LIGO- T1300503-v4

27th June 2013

Redesign of quad UIM coil driver and magnet size to
reduce magnetic coupling

Snippet of D070481-v4

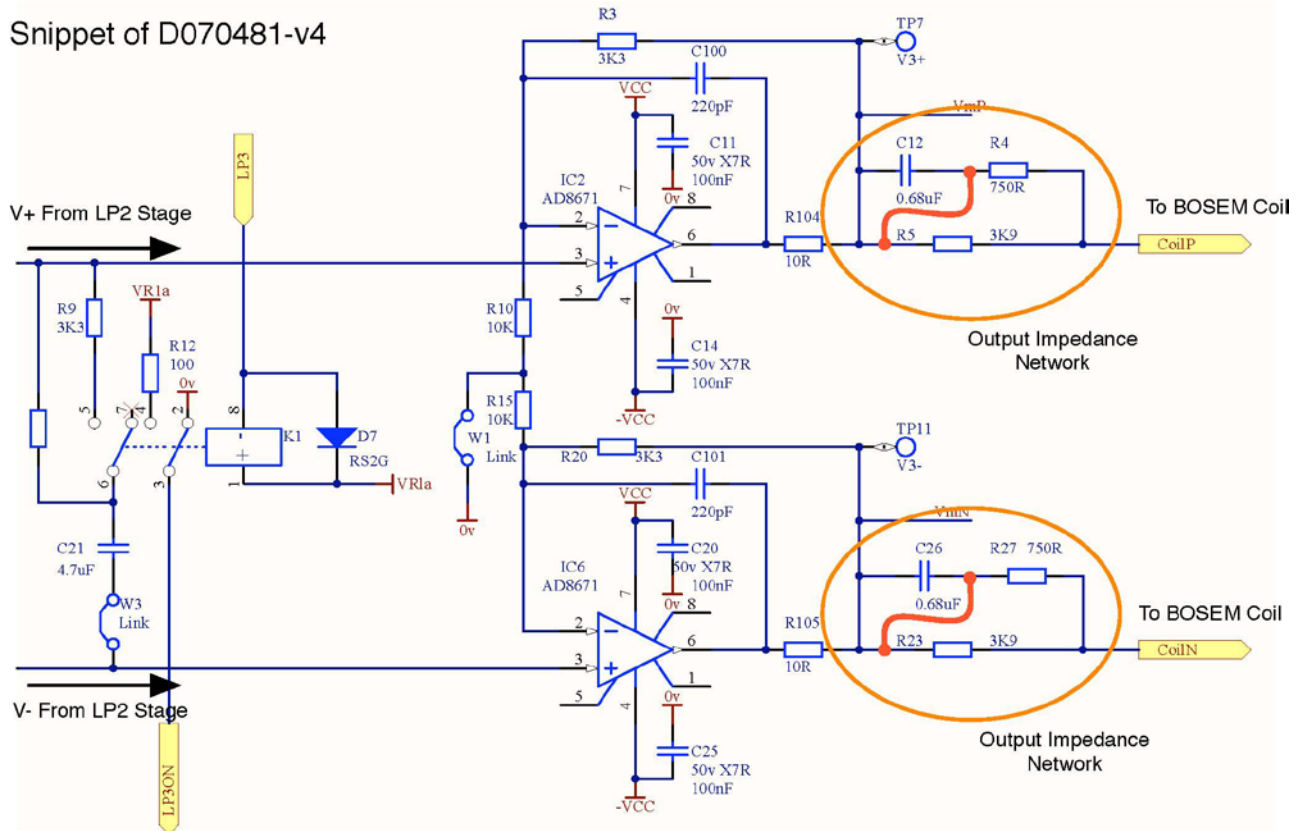
I've thought a little harder / more carefully about modifying the UIM driver (<<https://dcc.ligo.org/LIGO-D070481>>) to increase its drive strength. One easy fix (very similar to

what was done to modify the control HSTS M2 Triple Acquisition (TACQ) drivers, <<https://dcc.ligo.org/LIGO-L1200226>>), would be to short the output capacitors C12 and C26. This will change the DC output impedance by a factor of 0.16 (i.e. a reduction by a factor of ~6), and increase the transconductance of the driver from 0.15 [mA/V] to 1.02 [mA/V].

7 Appendix C

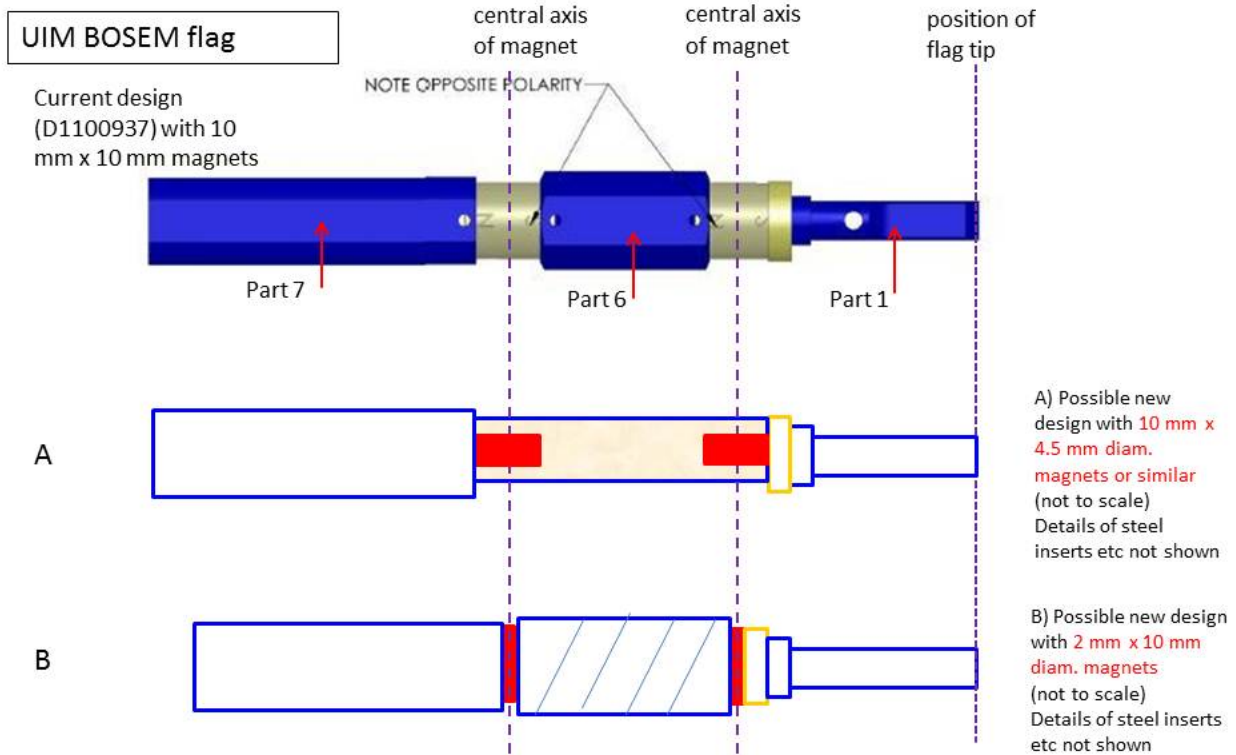
Note that the magnets are labeled as opposite polarity (which is correct) but are shown with same polarity in the top drawing. The drawing D1100937 has been updated on the DCC with red-lined version indicating correct polarities.

Case A): Redesign part 6 to be longer and smaller diameter and round, bored for an interference fit for new magnets. Outer diam. 10mm to fit assemblies at each end. Need to check sweet spot for possible flag length change.

Case B) Make part 6 longer by 8 mm, and make part 1 longer by 4 mm to keep flag tip at same separation from right hand magnet (but check sweet spot). Check if part 7 needs to be longer to mate with other parts. Might need to reduce diam. of part 6 if interferes with BOSEM central hole.
